Caiazza Comment on Hydrogen as a Zero-Carbon Firm Resource

Summary

Figure ES-2: Hourly Load/Generation Balance, CCP2-CLCPA Winter Wind Lull Case

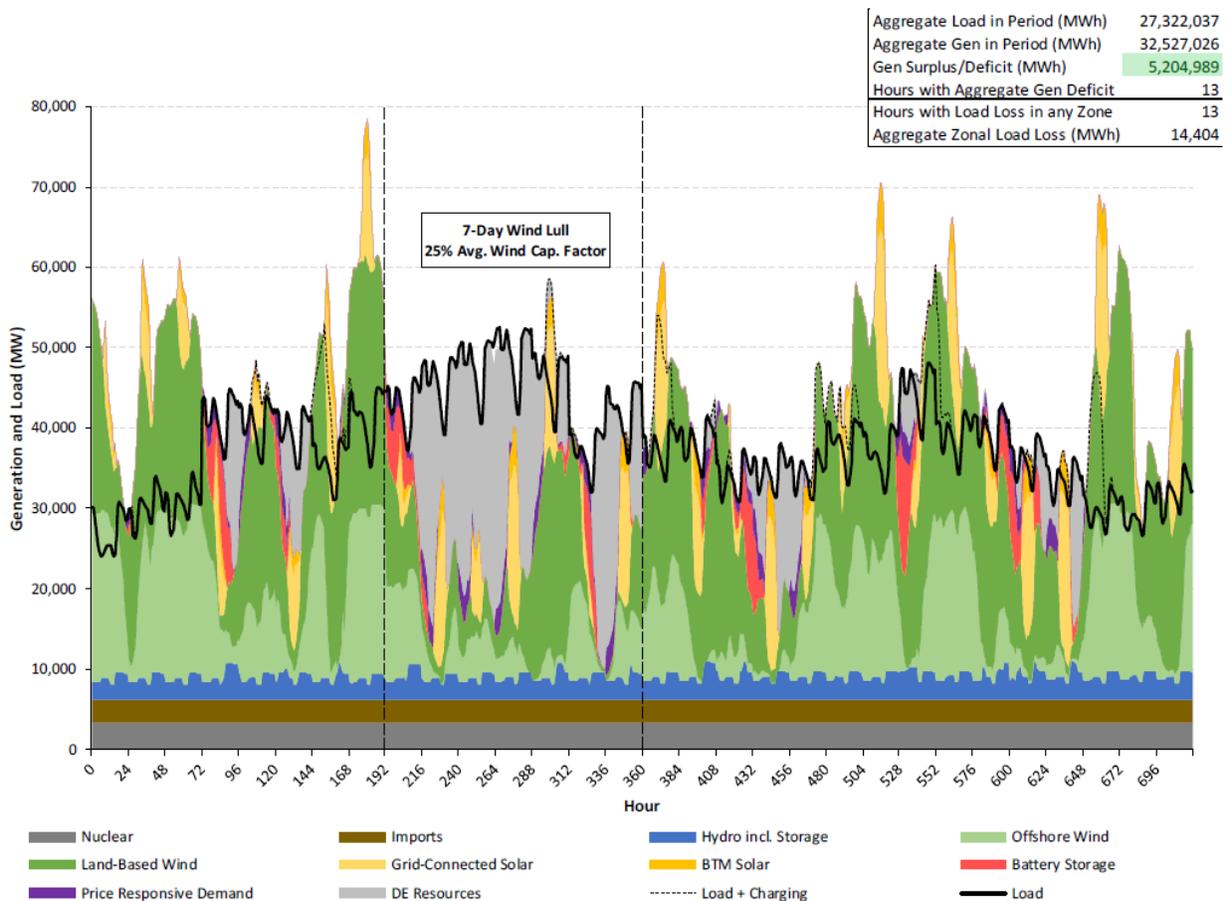
Table ES-2 from the report quantifies the total aggregated DEFR generation (MWh) needed for the extended wind lull. For a state-wide wind lull 6,988,838 MWh of energy is required to make up for the

poor wind and solar performance. In my opinion this may not represent the worst-case scenario because the analysis only evaluated wind data from 2007 – 2013. I submitted a [comment](#) recommending that a longer period of data be considered. In particular an analysis using, meteorological reanalysis descriptive data generated by modern weather forecast models but using original data from decades ago can be used to evaluate wind lulls. The [ERAS global reanalysis](#) data base provides hourly estimates of a large number of atmospheric, land and oceanic climate variables from 1950 to the present. Until that data set is used, we won't know the worst-case wind lull.

Figure 37. Impacts of Electrolysis Loads on Total Electric Loads in 2050

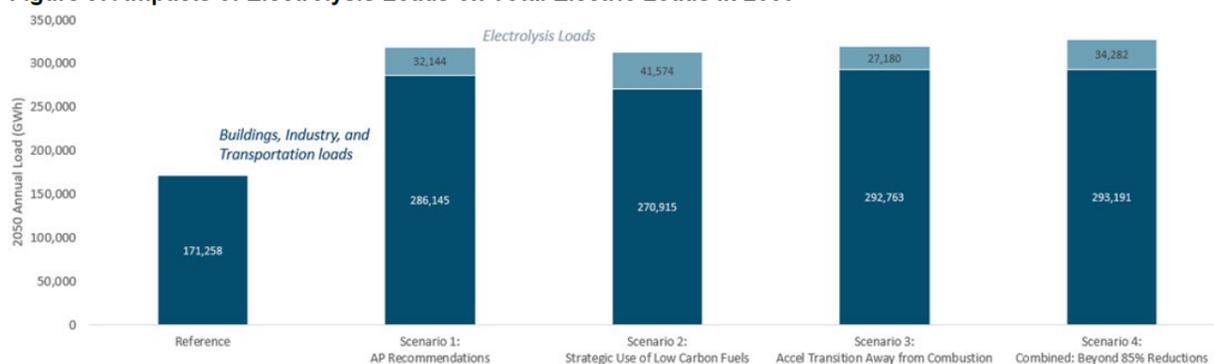
I interpret these last two paragraphs as a claim that the projected capacity and generation estimates include the power necessary to produce the hydrogen for all applications including the “zero-carbon firm resource” requirement. There is a problem however because it is not clear how they determined the load needed.

Figure 59. 2050 Installed Capacity, Scenario 2 and 100% In-State Hydrogen Production Sensitivity

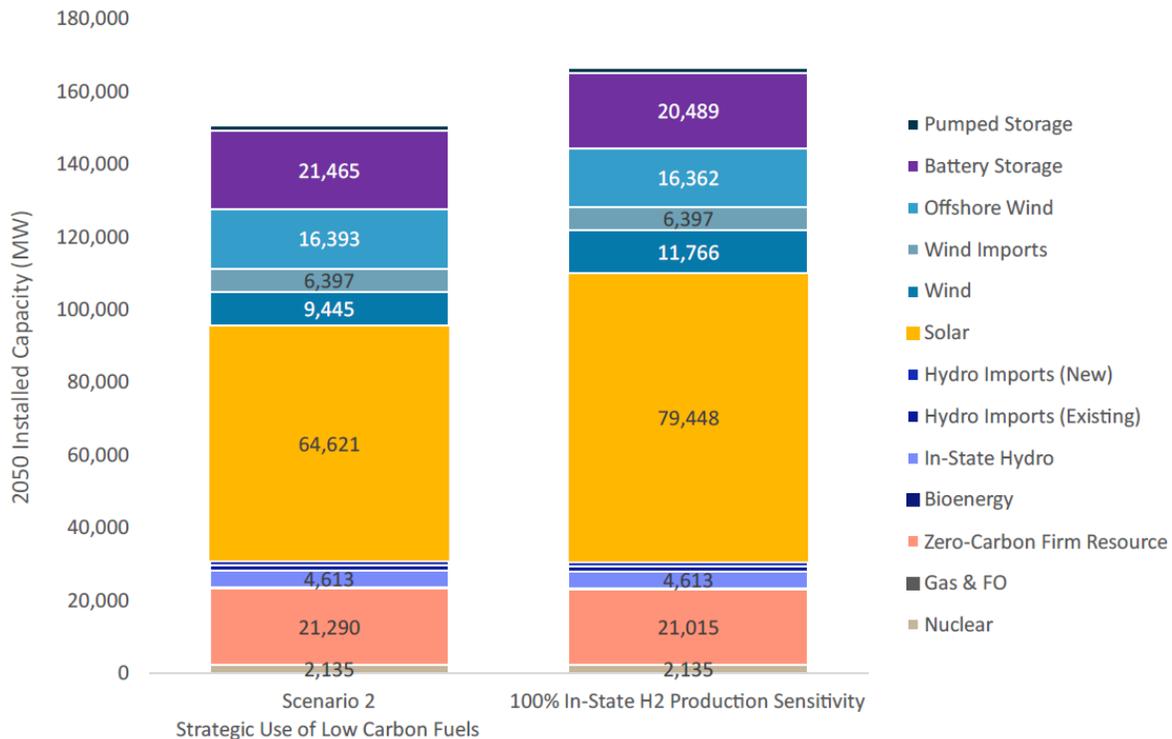
These two paragraphs present key numbers. Electrolysis will require 80,000 GWh of electricity, 2,300 MW of new onshore wind resources and 14,600 MW of new utility-scale solar development. There is a problem however. The critical DEFR condition is a winter-time wind lull and the proportion of wind to solar development is incompatible with a winter problem because the solar resource is so poor in the winter. As a result, just looking at a single worst-case period is insufficient. The hydrogen long-duration storage can be depleted by multiple periods of calm winds and solar dedicated to electrolysis won’t be able to replenish the hydrogen stores as effectively as other times of the year. This is another feasibility issue that must be addressed by the Final Scoping Plan and reinforces the need for the long-period analysis of historical meteorological data.
